STATE OF MAINE  
DEPARTMENT OF TRANSPORTATION  
16 STATE HOUSE STATION  
AUGUSTA, MAINE 04333-0016

January 9, 2018  
Subject: Barrel Bridge Replacement  
State WIN: 018957.00  
Location: York  
**Amendment No. 2**

BARRELL BRIDGE  
DOLLY GORDON BROOK  
YORK COUNTY

YORK  
MICROPILE DETAILS ABUT. 2

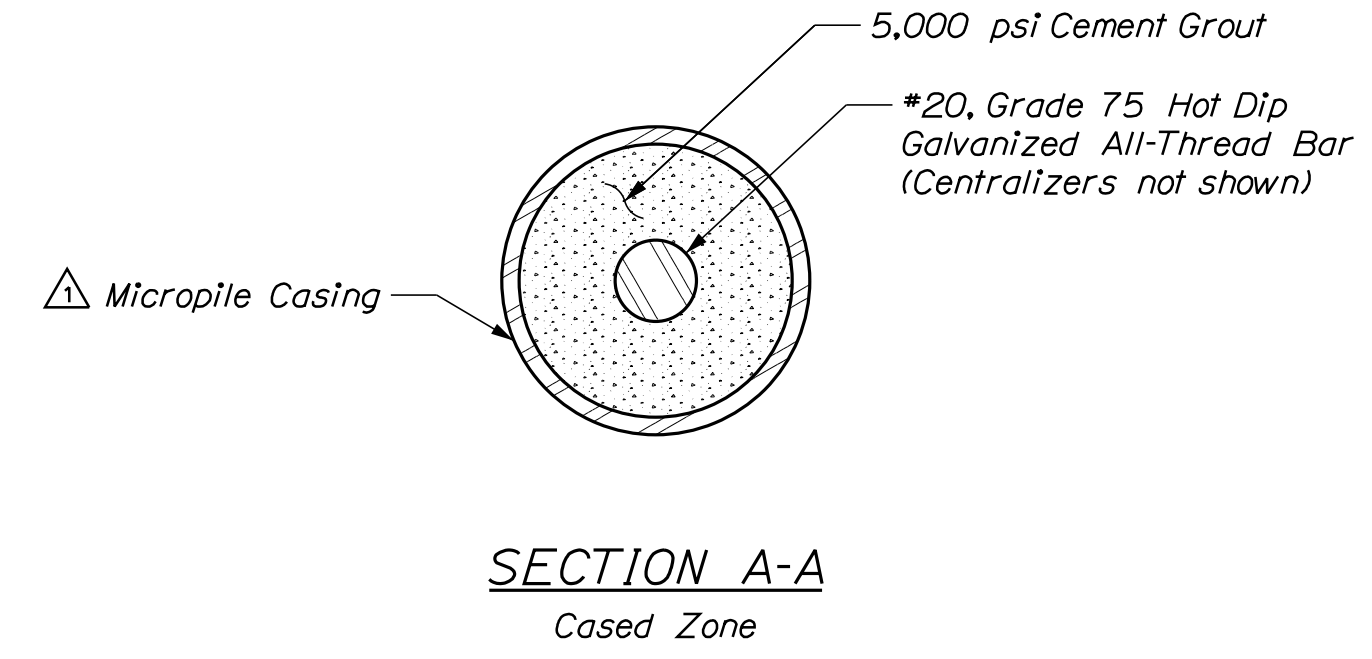
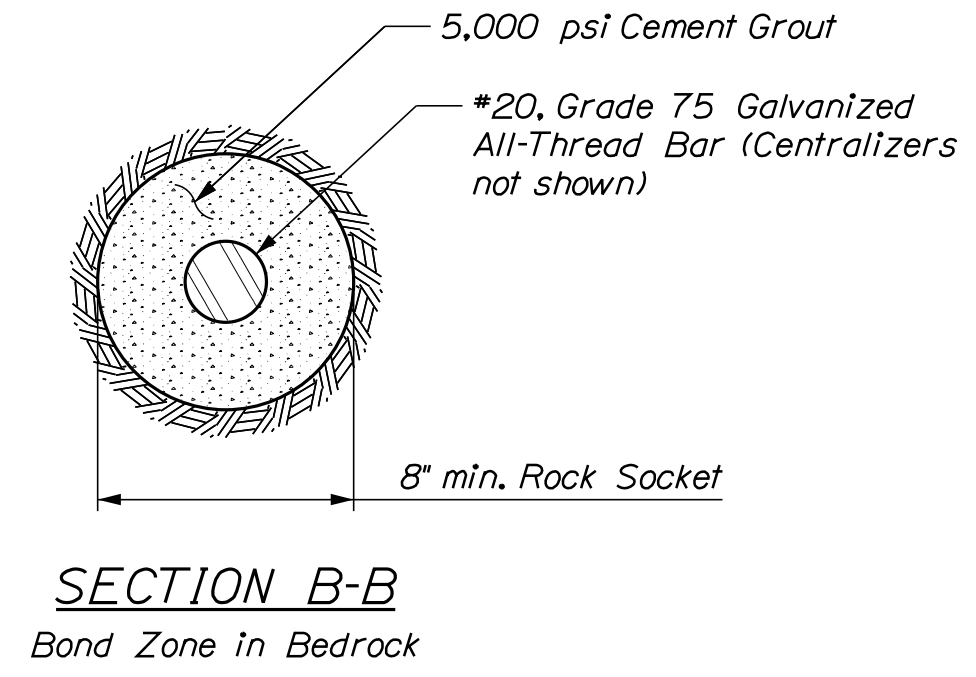
**REMOVE** SHEET NUMBER 19 OF 31, MICROPILE DETAILS ABUT. 2, and **REPLACE** with the attached, revised SHEET NUMBER 19 OF 31, MICROPILE DETAILS ABUT. 2.
